SUBJECT: Forwards updated response to NUREG-0612, "Control of Heavy
 Loads" for Unit 2. Submittal anticipates NRC comments similar
 to comments issued for Unit 1. Changes made equivalent to
 Unit 1 submittal.

PGandE Letter No.: DCL-84-373

Re: Docket No. 50-275, OL-DPR-80
Docket No. 50-323
Diablo Canyon Units 1 and 2
Updated Response to NUREG-0612, "Control of Heavy Loads"

SUBMITTAL CHANGE PAGES

**UNIT 1
DIABLO CANYON SITE**
FIGURE 2.1.3a-7
TURBINE BUILDING EQUIPMENT
SAFE LOAD PATHS AND LAYDOWN AREAS
ELEV. 140'-0"

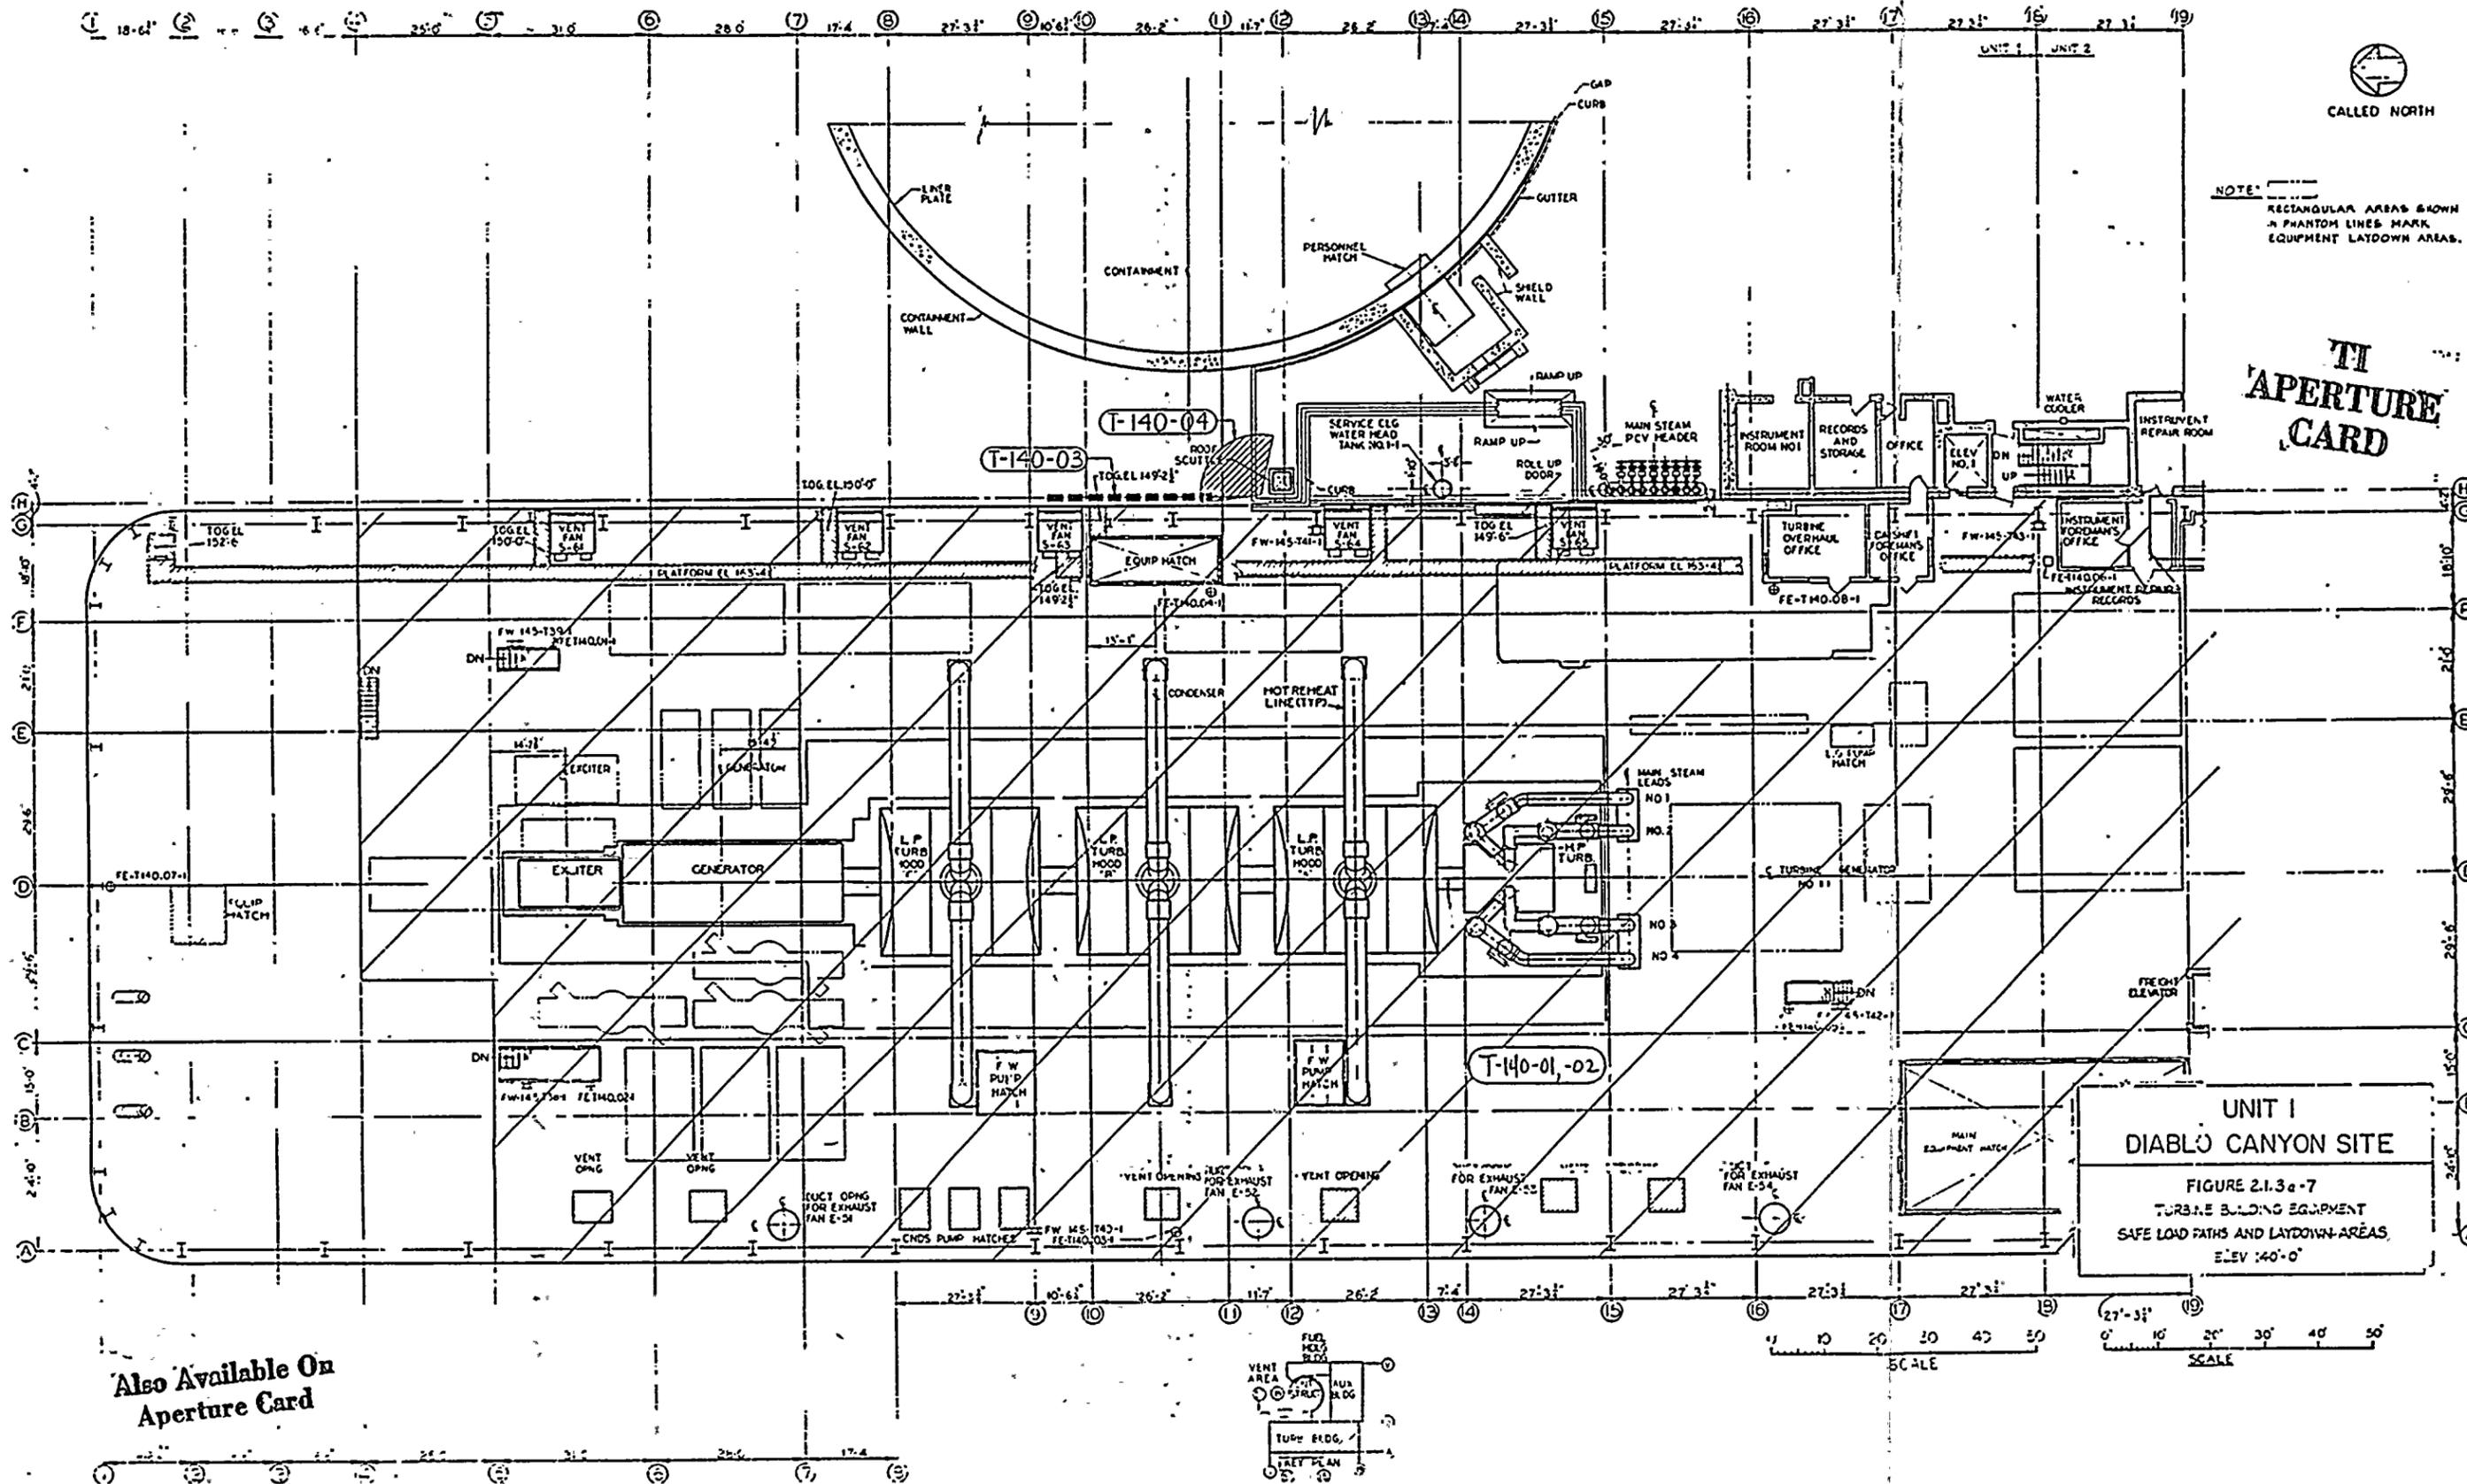
2. The fourteen heavy load paths under the Turbine Building Bridge Cranes are replaced with one large load path covering most of the turbine deck, as shown in the revised Figure 2.1.3.a-7 for Unit 1 and 2.1.3.a-4 for Unit 2. The new load path is safe because there is no spent fuel or safe-shutdown-related components under it.
3. The reactor coolant pump motor lift rig has now been modified, and its analysis, new in Unit 2, has been revised in Unit 1 to reflect the as-built condition.

<u>CHANGE PAGE(S)</u>	<u>REPLACING</u>	<u>EFFECT</u>
<u>I. Unit 1</u>		
2.1.1-2	2.1.1-2	Revises minimum heavy load weight
2.1.2-5	2.1.2-5	Revises load weight of fuel-handling cranes
Figure 2.1.3.a-7	Figure 2.1.3.a-7	Replaces turbine deck load paths with one large one

UNIT 2
DIABLO CANYON SITE
FIGURE 2.1.3-4
TURBINE BUILDING
SAFE LOAD PATHWAY
BLV. 140-00

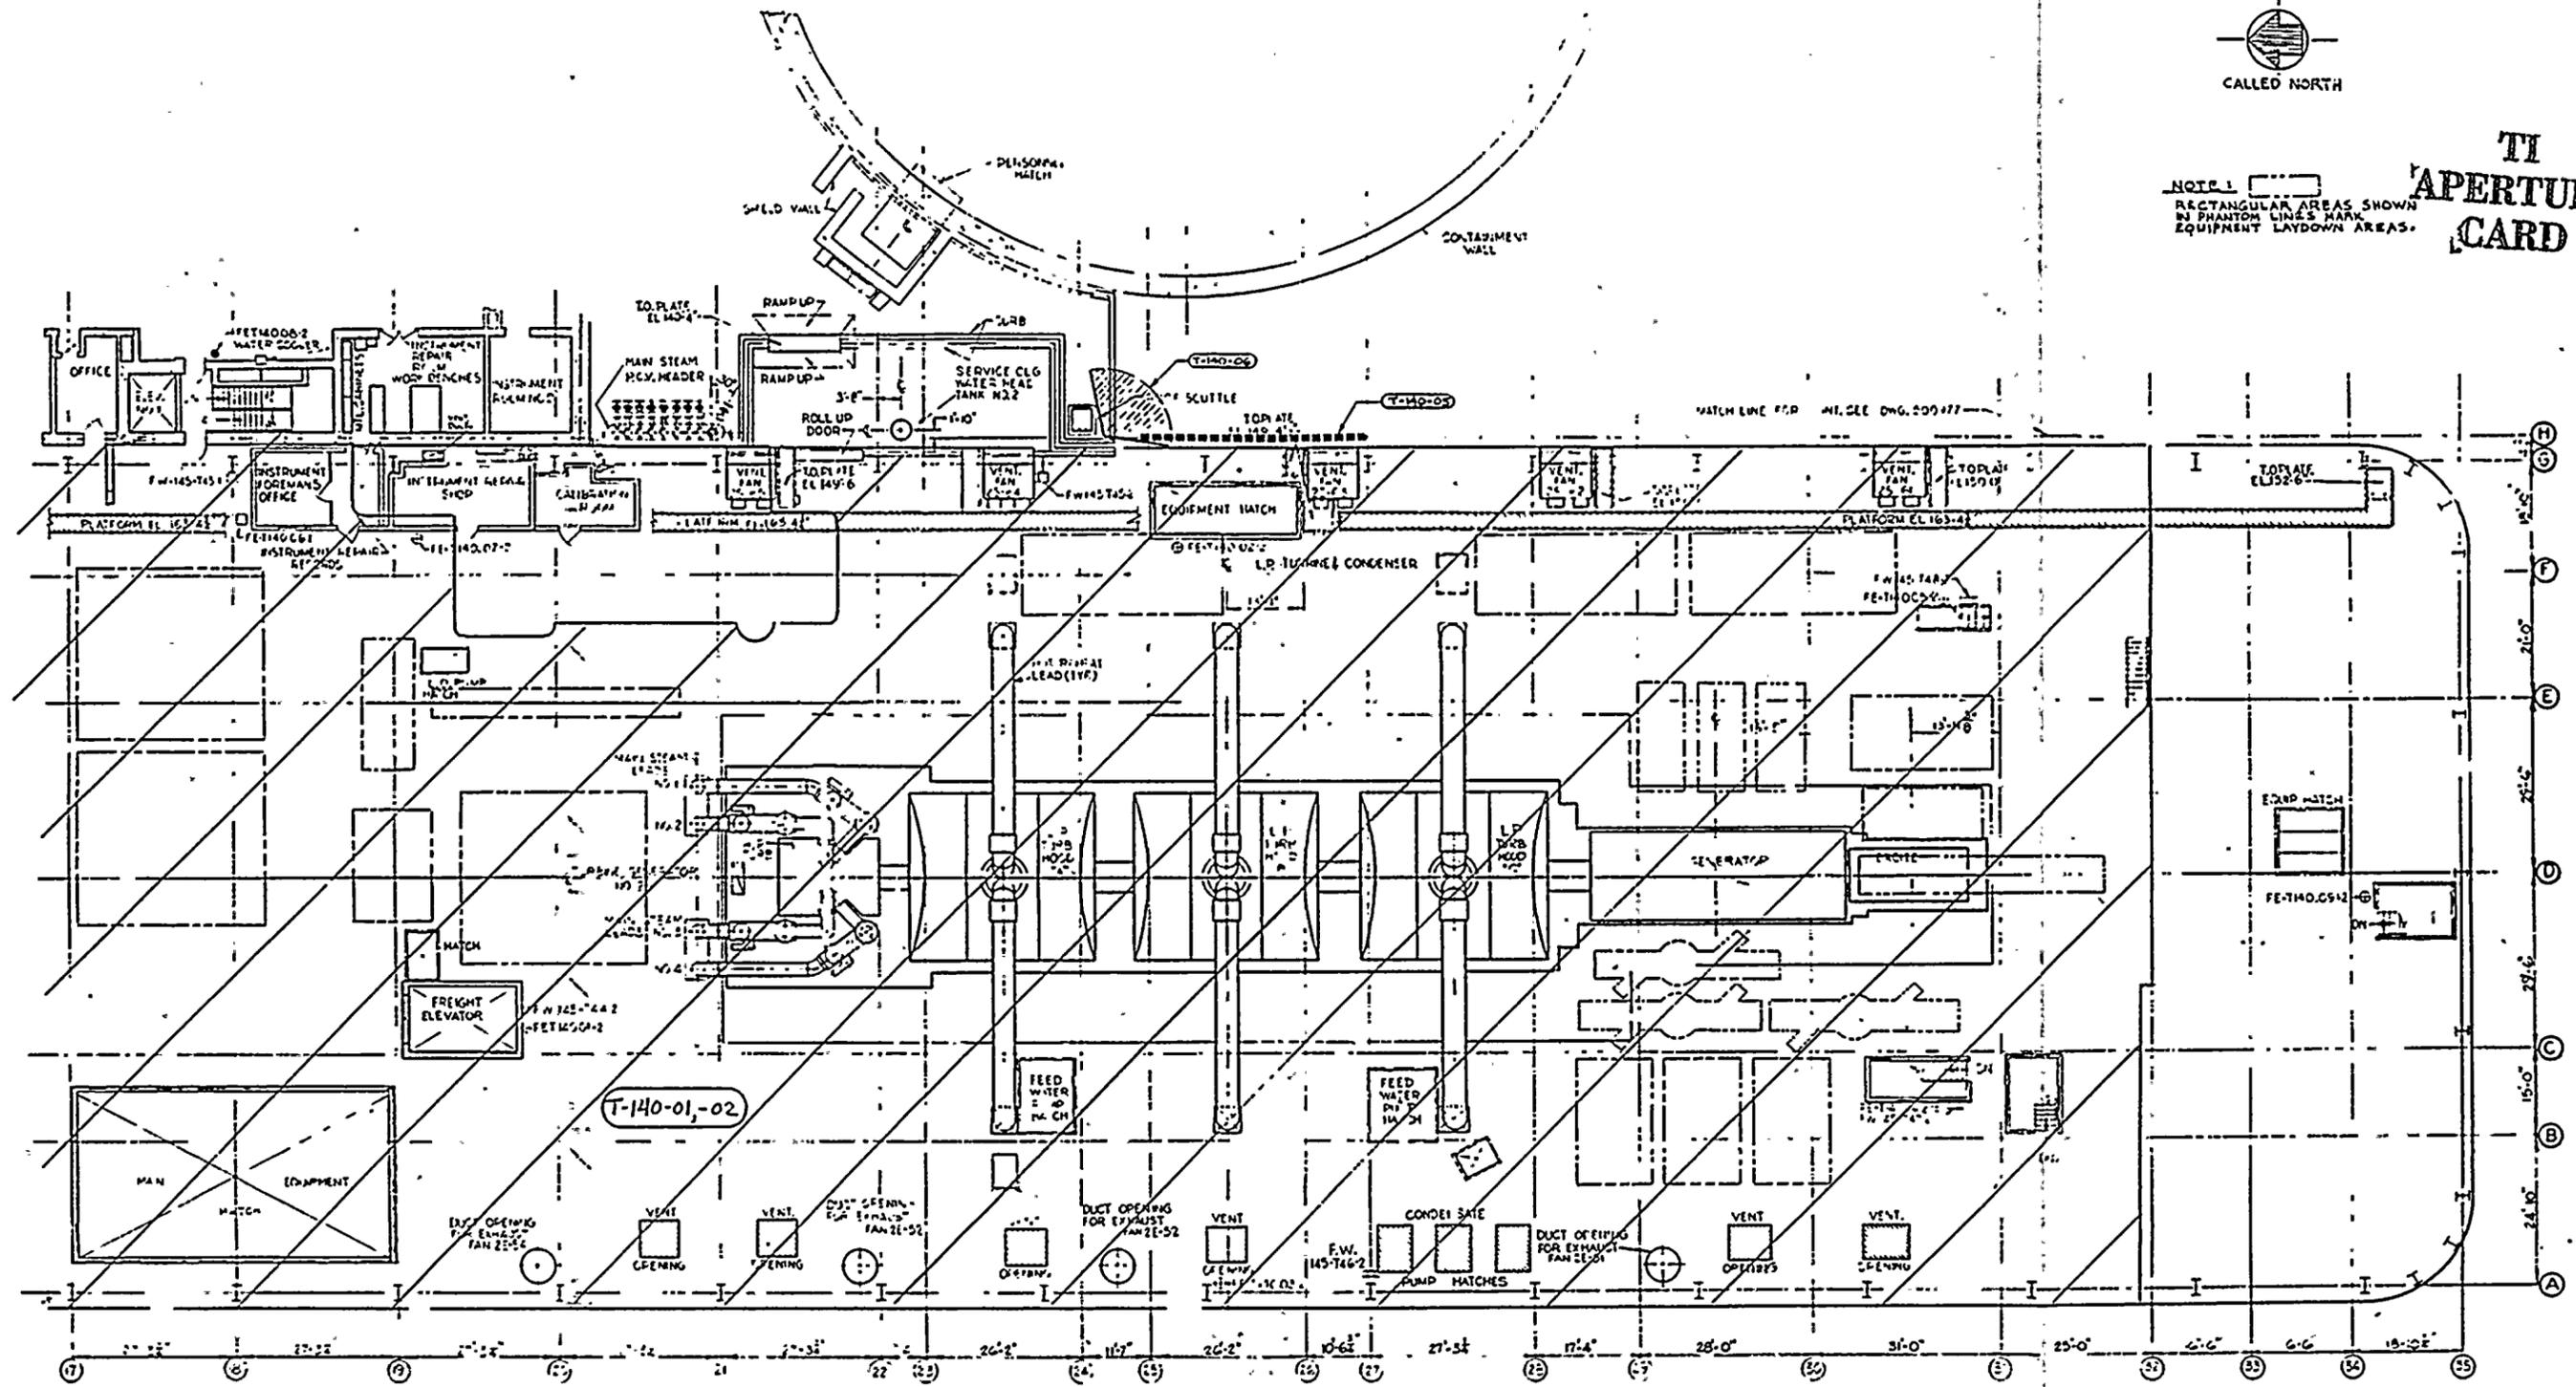
2.1-4	2.1-4	Revises minimum heavy load weight
2.1-11	2.1-11	Revises load weight of fuel-handling cranes
Figure 2.1.3.a-4	Figure 2.1.3.a-4	Replaces turbine deck load paths with one large one

FIGURE 2.1.3.d-5
REACTOR COOLANT PUMP
MOTOR LIFTING DEVICE

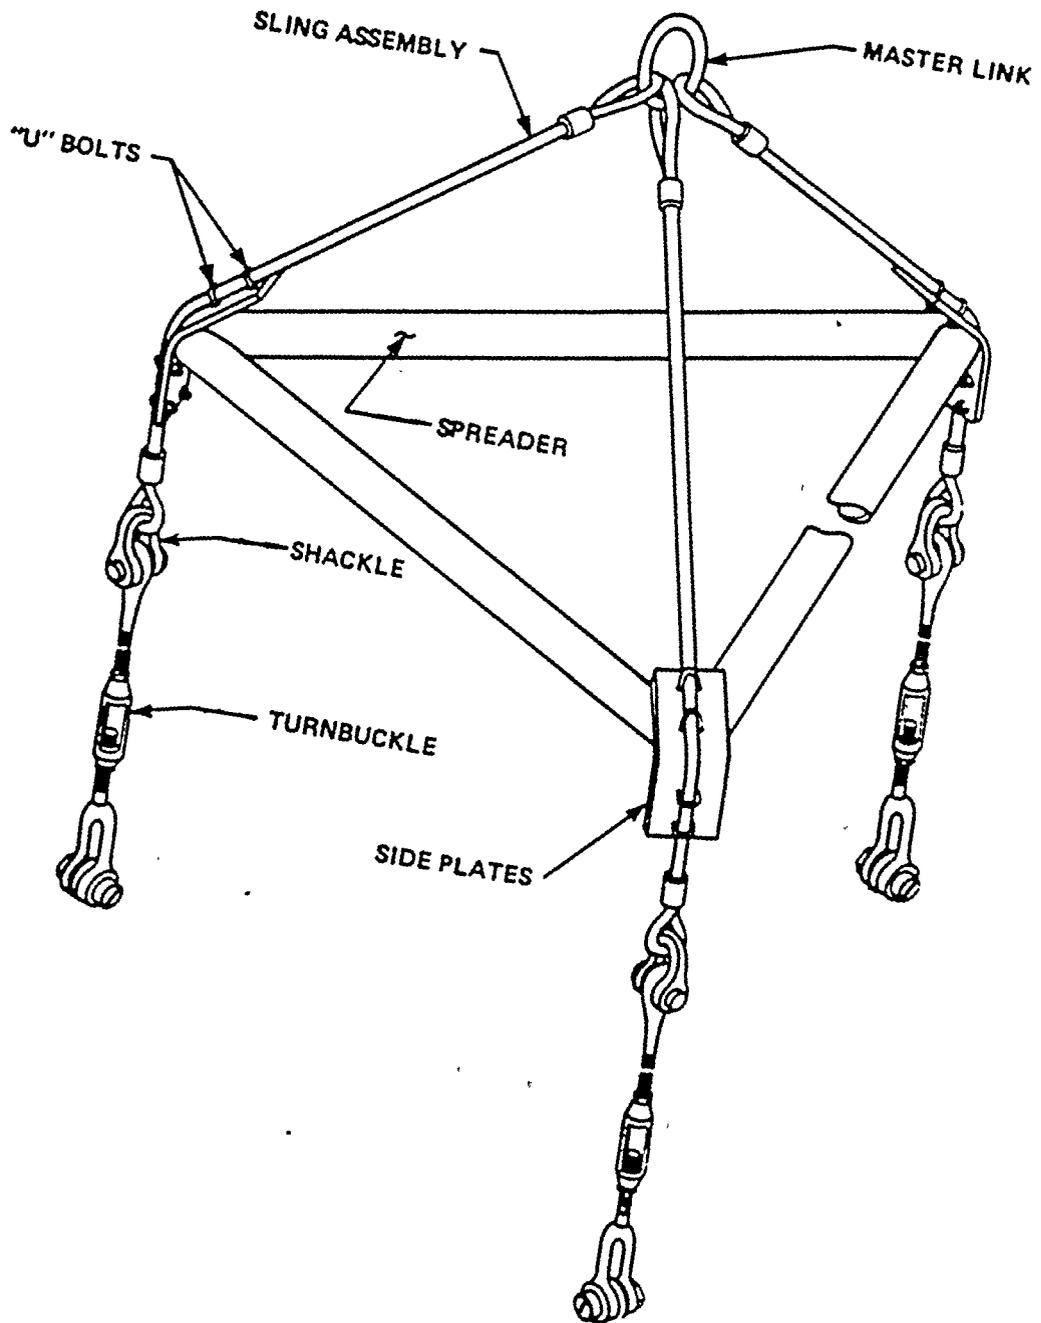
2.1-23	2.1-23	Makes Footnote 2 more specific
2.1-26 and -27	2.1-26 and -27	Adds treatment of RCP motor lift rig, and specifies exclusion of other lift rigs more narrowly
Figure 2.1.3.d-5	---	Adds new figure for RCP motor lift rig

The reactor coolant pump motor lifting device, shown in Figure 2.1.3.d-5, consists primarily of three sling assemblies and a spreader assembly. The sling assemblies are connected at the top to a master link engaging the polar crane hook. Each sling assembly consists of a sling, a pair of shackles, and a turnbuckle, all general-purpose catalogue items. The slings have been replaced with new slings, each rated at 20 tons under ANSI B30.9-1971. Design safety margins for these items were derived by
